**MEMORANDUM**

TO: BRIAN JOHNSON, WATER SYSTEM  
SPECIALIST  
FROM: KERRI SIDEBOTTOM, P.E.  
DATE: MAY 14, 2024  
SUBJECT: 304 2<sup>ND</sup> STREET NE, FIRE FLOW  
AVAILABILITY  
CITY OF PUYALLUP, PIERCE COUNTY,  
WASHINGTON  
G&O #21415.20

# HYDRAULIC MODEL FOR 304 2ND ST NE

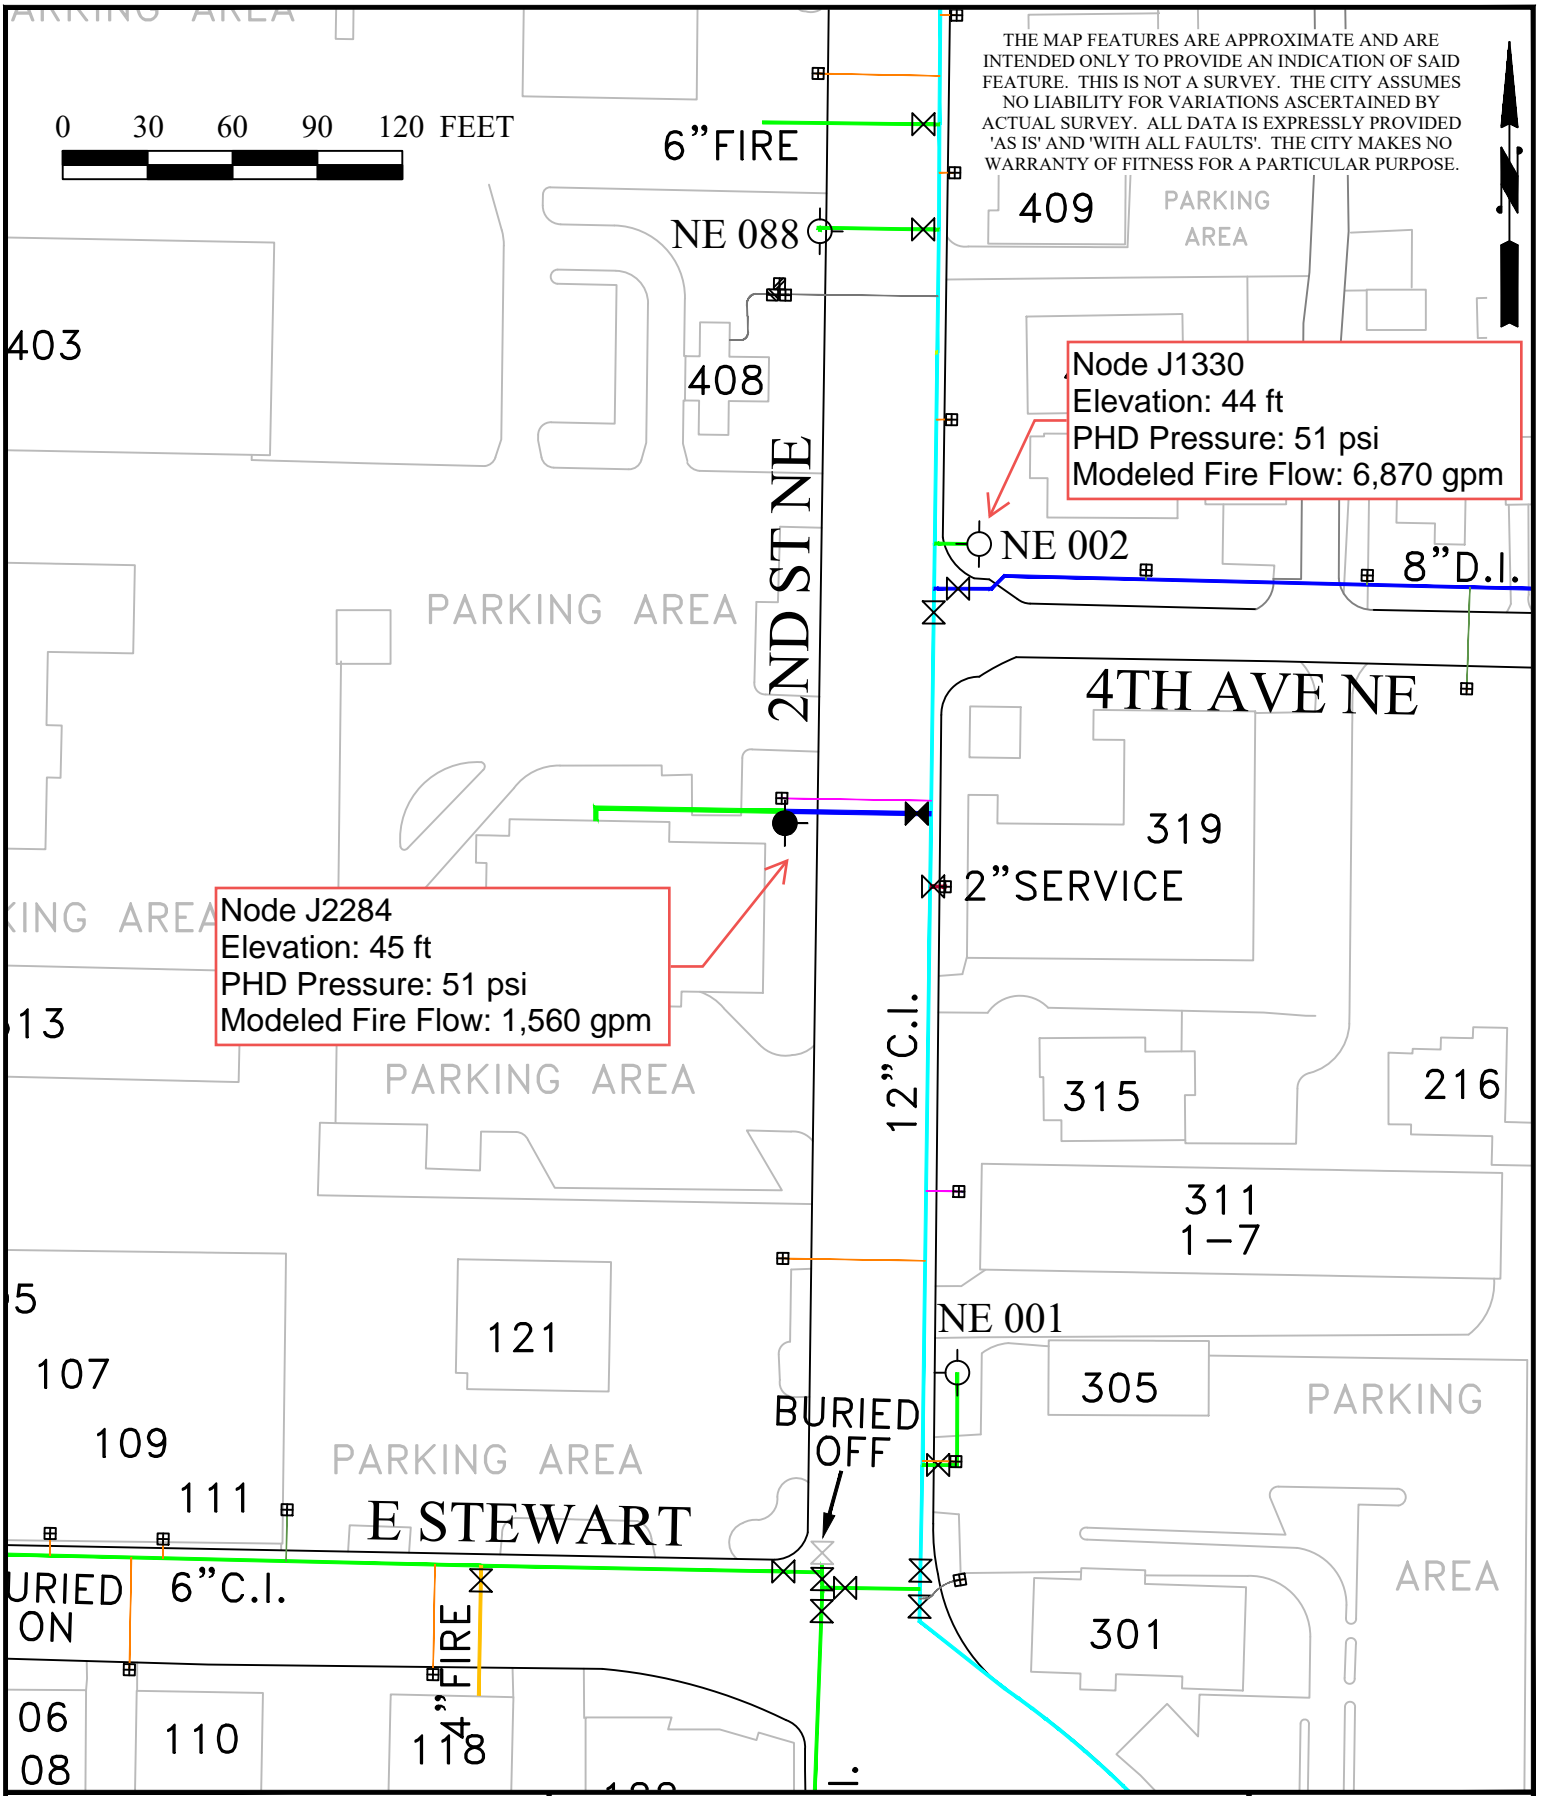
- The available fire flows and pressures are measured at two nodes corresponding to one existing hydrant and one proposed hydrant within and near to the development, shown in the attached figure.
- Water system demands are based on projected 2038 demands and reservoirs are depleted of fire suppression and equalizing storage, as established in the *2019 Water System Plan (WSP)*, approved by the Department of Health (DOH). The City's water model was updated in 2021 to reflect additional system improvements since the WSP was developed.
- All pump stations are idle, and the Salmon Springs source is operating at 1,100 gallons per minute (gpm).

The development is located in Zone 1, which is supplied by Maplewood Springs and the 15<sup>th</sup> Avenue SE Reservoirs. The system was modeled with the proposed piping indicated on the attached figure.

Available fire flow was modeled at one existing hydrant and at one proposed hydrant. The existing hydrant is located on the 12-inch pipe along 2<sup>nd</sup> Street NE, while the proposed hydrant will be located on a dead-end, 8-inch main extending from the 12-inch pipe. The results of this modeling are included in Table 2. The modeled fire flow is available at either hydrant individually, but not simultaneously.

Fire flow to the proposed hydrant is limited by the 10-fps maximum velocity through the proposed 8-inch pipe, while flow to the existing hydrant is limited by the 20-psi minimum pressure.

It should be noted that the dead-end, 8-inch main within the proposed site can only provide 1,560 gpm, due to the City's 10-fps velocity limitation considered for the fire flow analysis. Therefore, if 1,500 gpm is required at the hydrant located on a dead-end main, there is essentially no additional flow available for the sprinkler system supplied by the same dead-end main, unless a larger pipe is installed.
